ROAD SAFETY AUDIT

US-31 (REYNOLDS RD
TO SULLIVAN RD)

CITIES OF INTERLOCHEN AND GRAWN,
MICHIGAN

Cincar Consulting Group, LLC

Figure 14: Roundabout layout at US-31 and J Maddy Pkwy

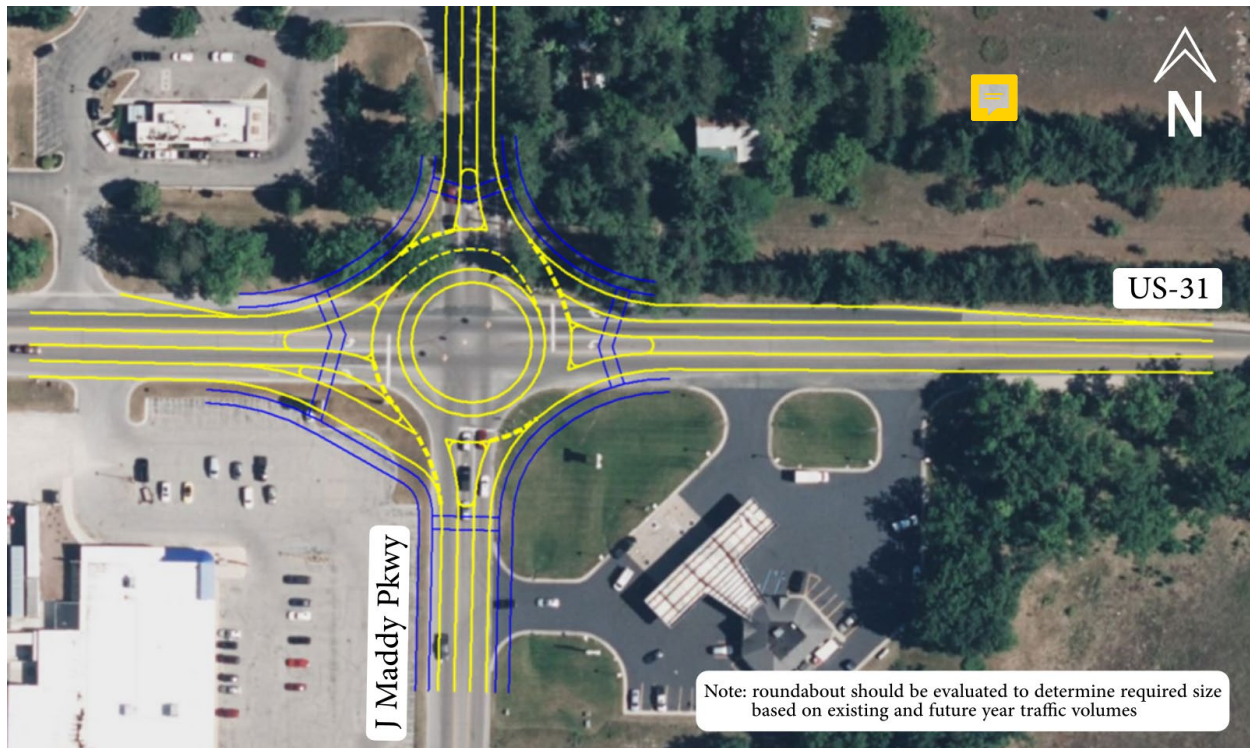
- **Consider a roundabout:** The installation of a roundabout would be useful in reducing the travel speed on approaches to the intersection as well as the adjacent corridor. However, the number of lanes would need to be evaluated along with incorporation of proper pedestrian facilities, signage, and pedestrian refuge, to ensure safe access to the intersection for all users. A layout of a potential roundabout design is shown in **Figure 14**.

Figure 16: Advanced Warning Flasher with LED border sign

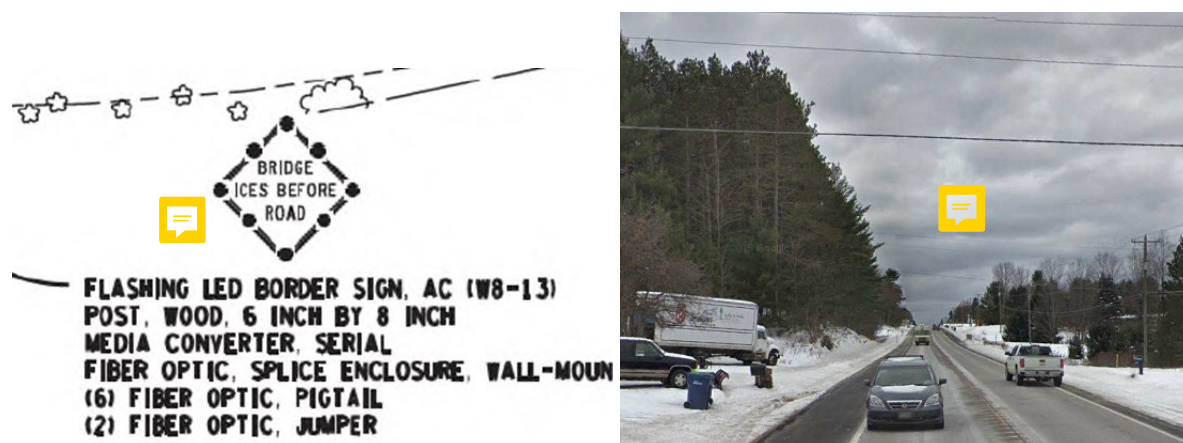
The icy roadway conditions during the winter months pose safety concerns along the US-31 corridor. An existing ITS Environmental Sensor Station (ESS) site that monitors the weather conditions has two pucks in the roadway, where both are located on US-31 between Betsie River Road and Gonder Road. Large trees on the southside of US-31 shade the roadway and may contribute to the ice not melting on the roadway. The highest number of crashes associated with icy, wet, and snowy roadway conditions are located a half mile to the west and a half mile to the east of the US-31 and J Maddy Parkway intersection.

- **ITS ESS Site and advanced warning signs:** Utilize the existing two sensors and add advanced warning signs (LED border or flasher) to alert drivers of the downstream roadway conditions
- **Clear pine trees** in the area to eliminate or reduce the shaded area along the roadway
- **Add delineators** on shoulders to prevent vehicles from veering off the roadway
